Proposal #30: 4992-00-60, WISC 2025041
C Menasha, Racine Street
Third Street to Ninth Street
Loc Str
Winnebago County

Letting of November 12, 2024

This is Addendum No. 02, which provides for the following:

Addendum No. 02
ID 4992-00-60
Revised Sheet 84
November 5, 2024

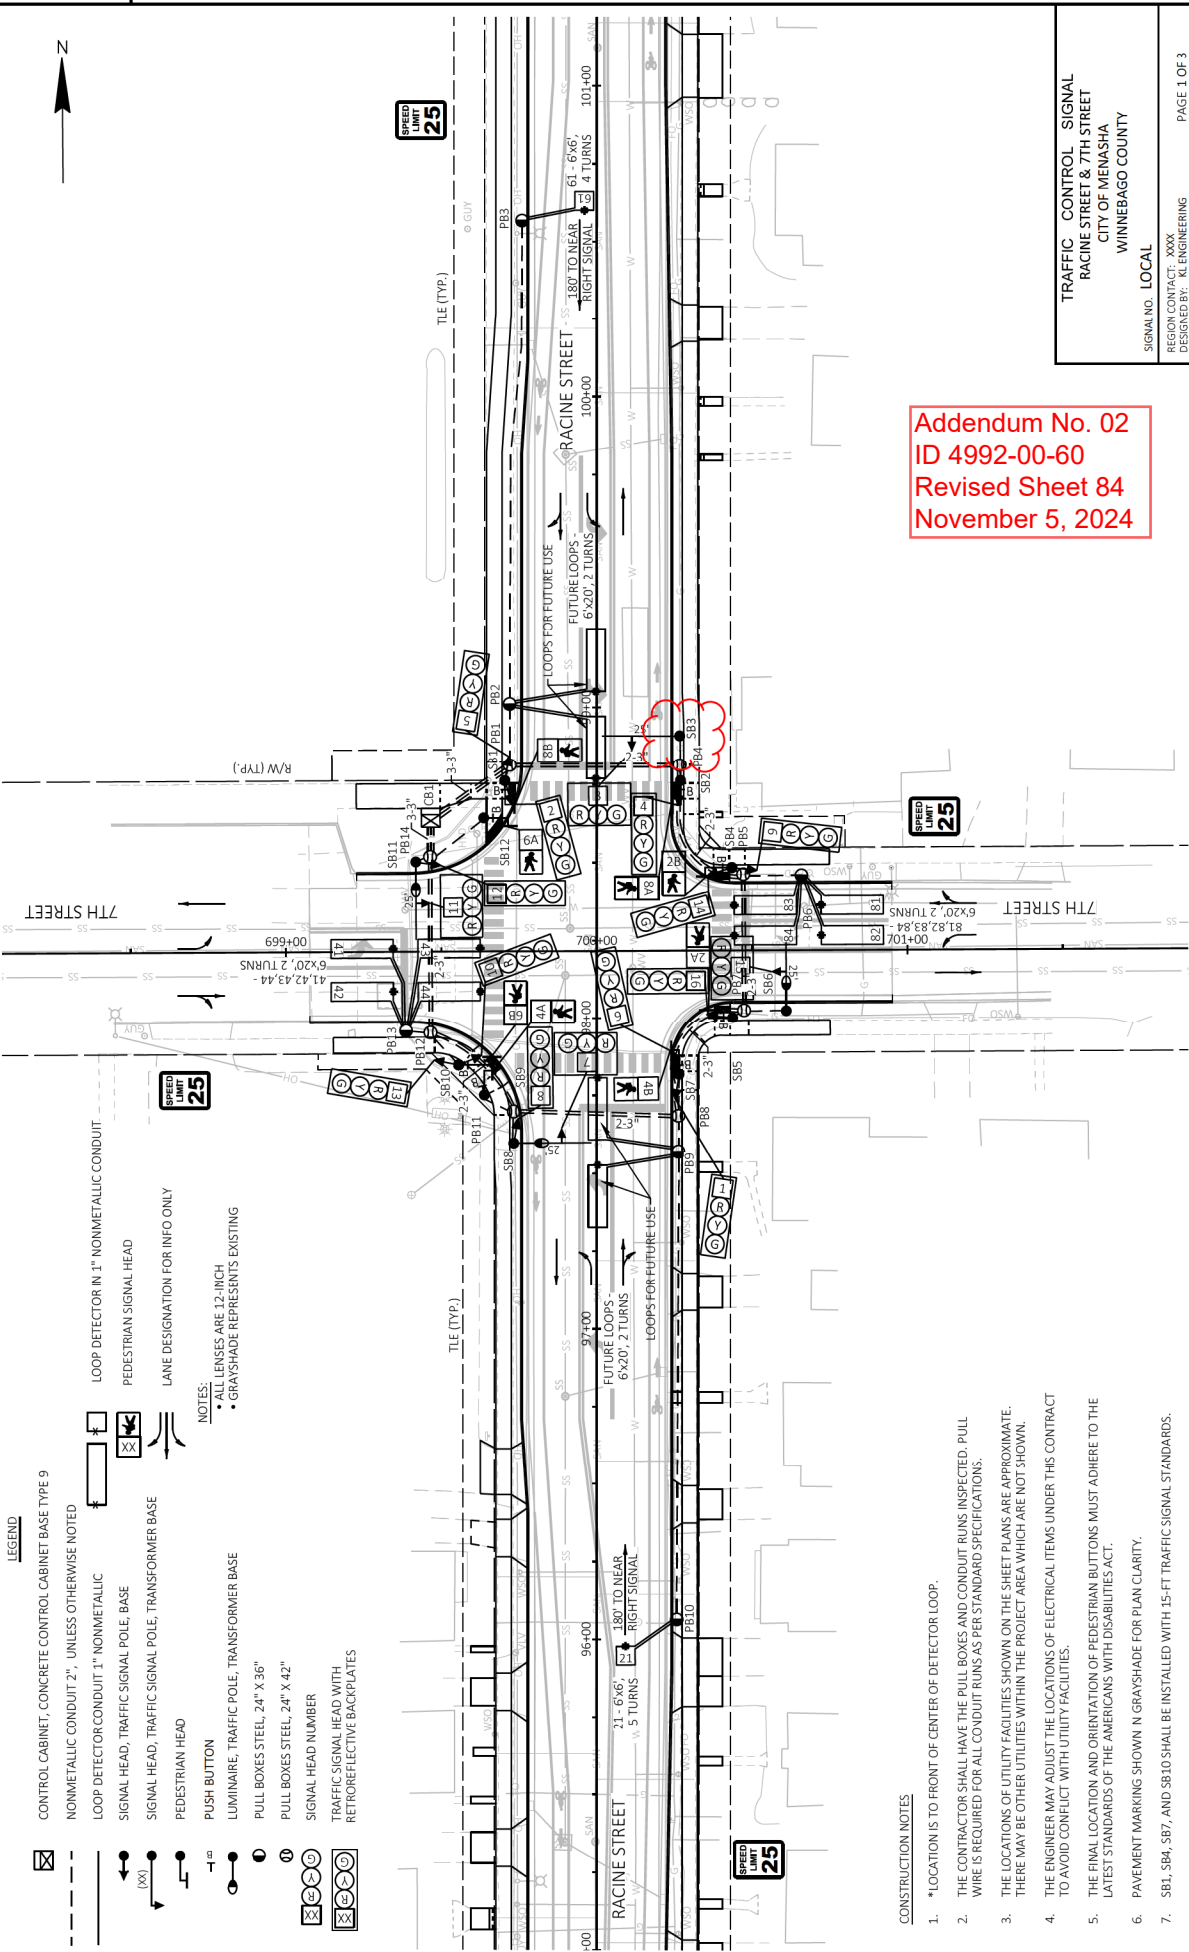
Revised Plan Sheets	
Plan Sheet	Plan Sheet Title (brief description of changes to sheet)
84	Traffic Signal Plan (Revised SB3 from Type 3 to Type 2 pole and removed luminaire/wire)
86	Cable Routing (Revised Lighting UF 2-12 AWG w/ Ground table)
134	Miscellaneous Quantities (Added 657.0305 and revised 657.0310, 657.0609 and 659.1120 quantities)
136	Miscellaneous Quantities (Revised 655.0305 and 655.0610 quantities)
